Final RCRA Facility Investigation Phase 2 Work Plan Parcel 23 Revision 1.0

Fort Wingate Depot Activity
McKinley County, New Mexico

April 29, 2019

Army Response to October 31, 2018 Disapproval Letter
April 25, 2019

P23 Army/NMED Coordinated Path Forward:

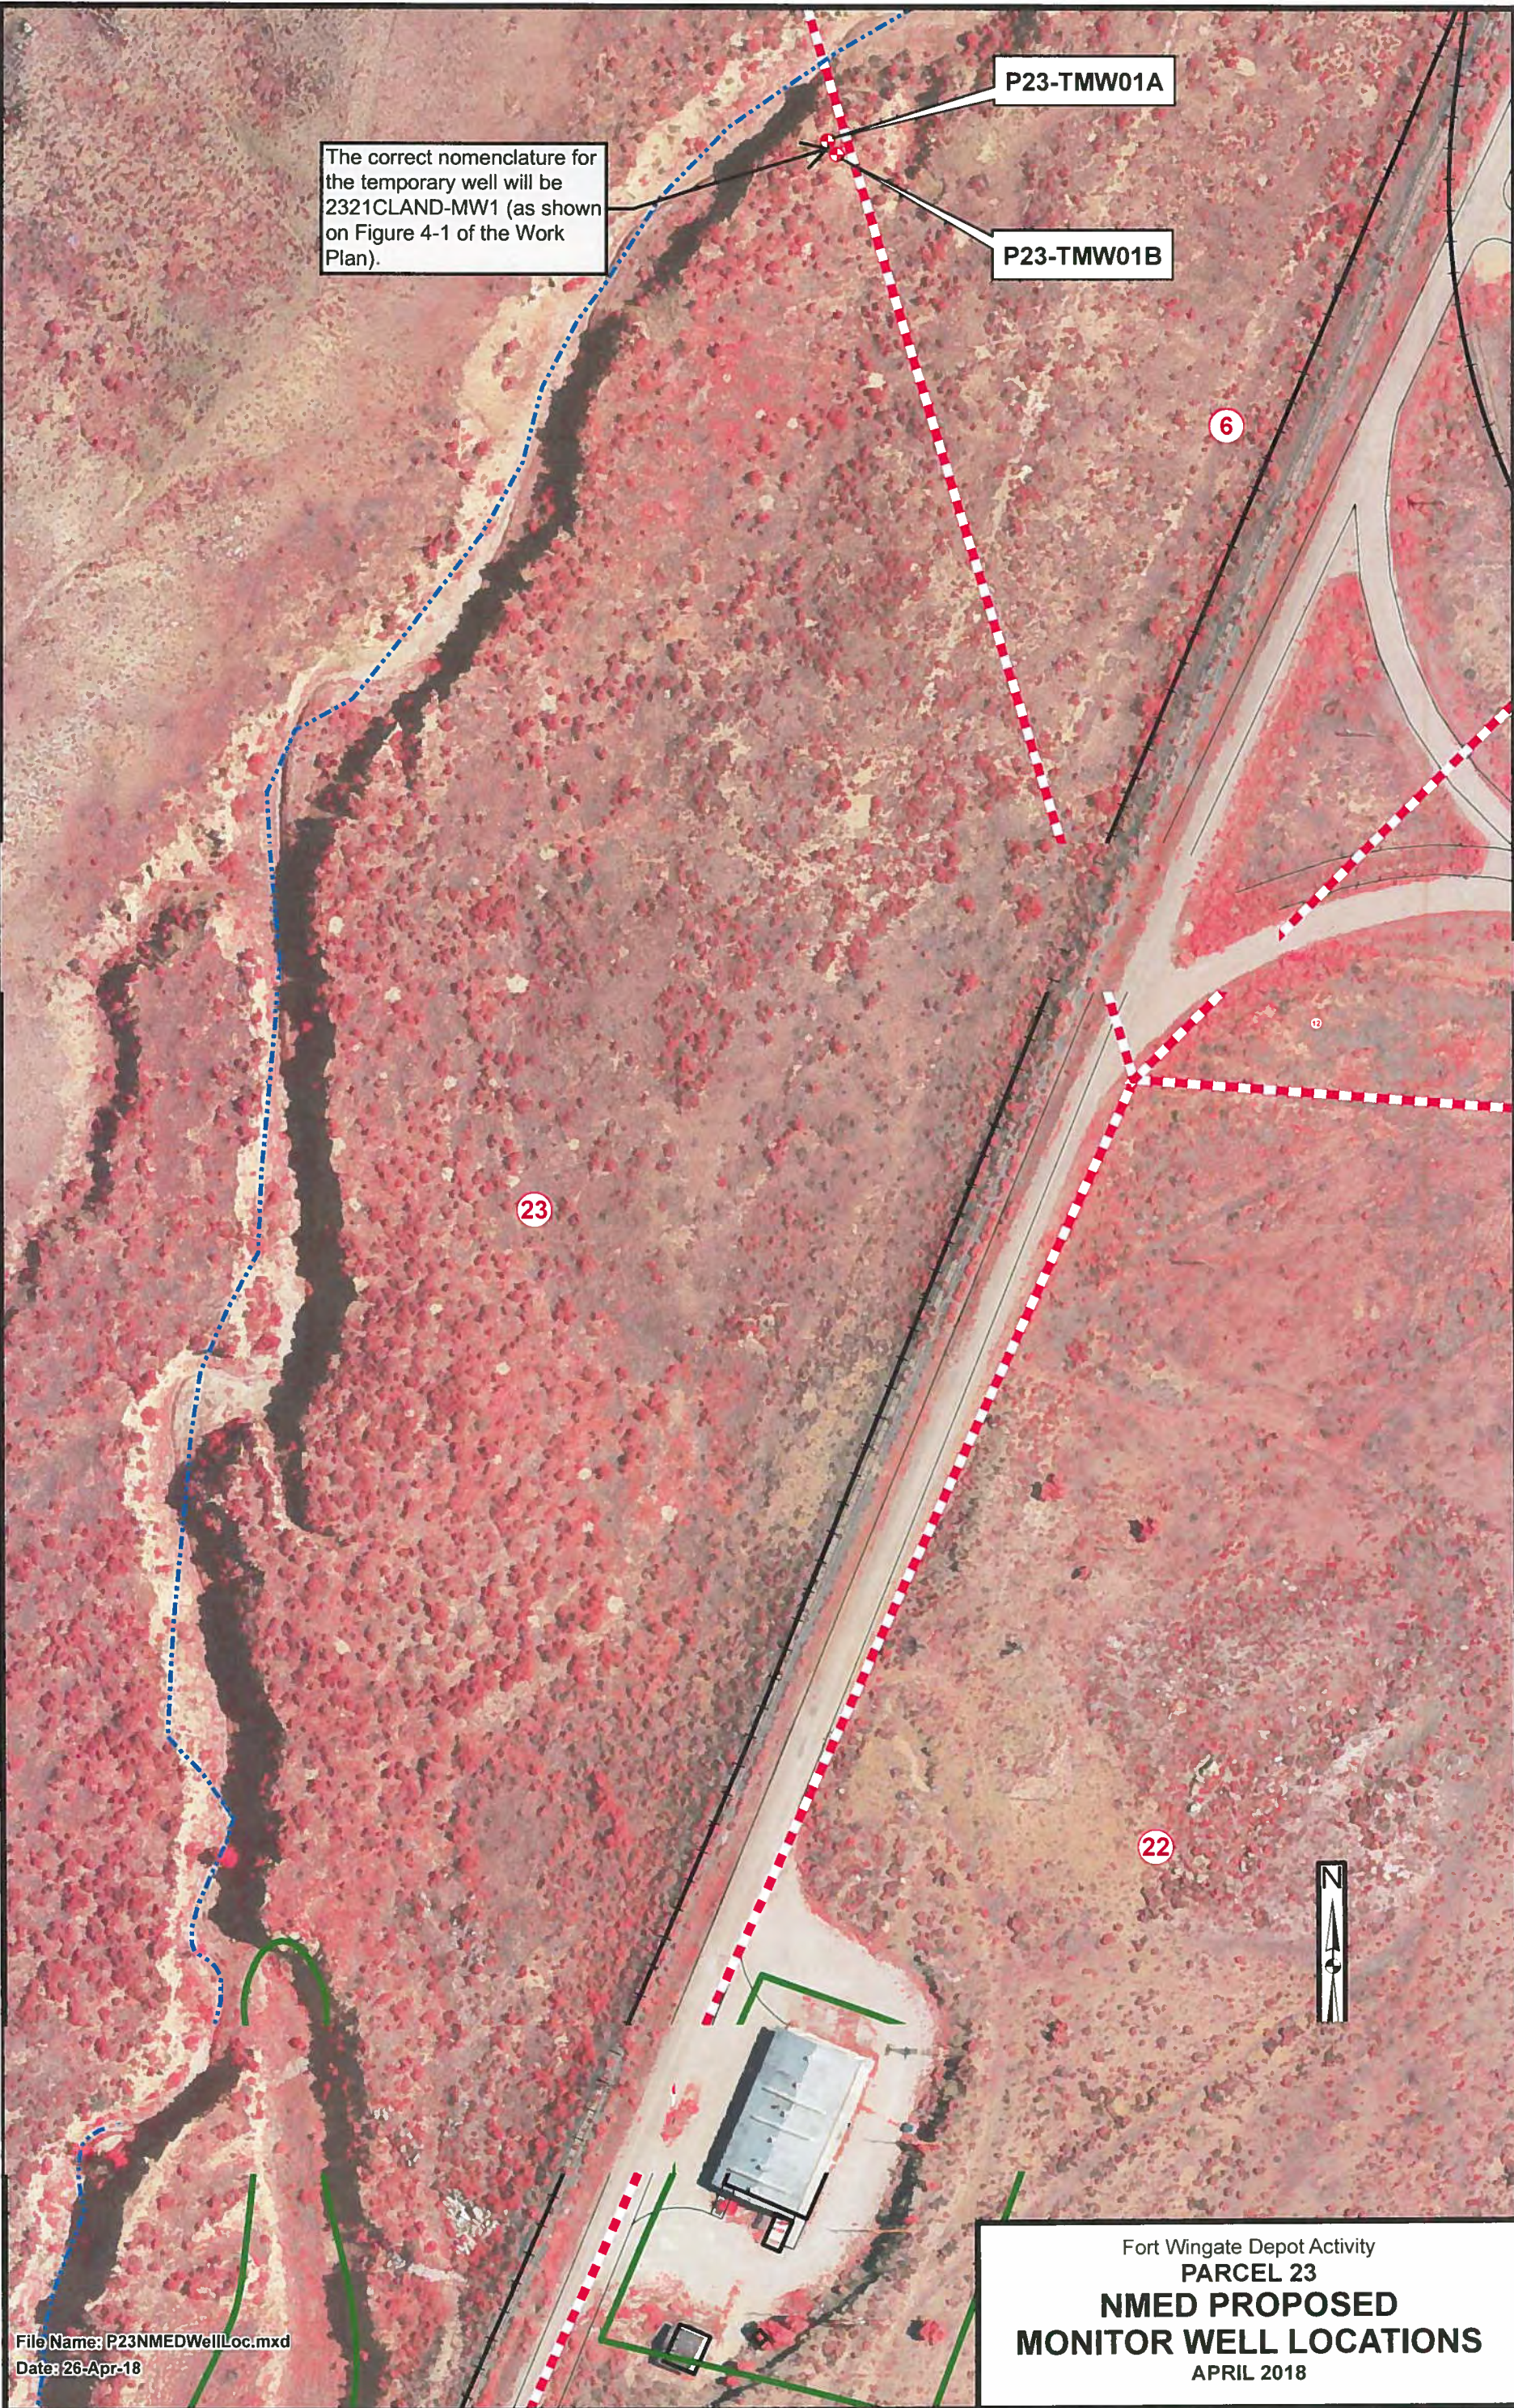
Attached is a GPS location of a temporary monitoring well location at Parcel 23 that we marked Wednesday (April 25) afternoon.

1. The drill rig is to get as close to the Arroyo as safely as possible, i.e. labeled TMW-01A or TMW-01B (P23NMEDWellLoc.pdf)
2. The temporary monitoring well (TMW 1) is located downgradient of former Central Landfill (P23NMEDWellLoc.pdf)

3. If no groundwater is found at suitable depth (100 feet) then no need to install monitoring wells.
4. If groundwater is found, we will collect water samples for analyses of chemical of potential concerns (COPCs).

The correct nomenclature for the temporary well will be 2321CLAND-MW1 (as shown on Figure 4-1 of the Work Plan).
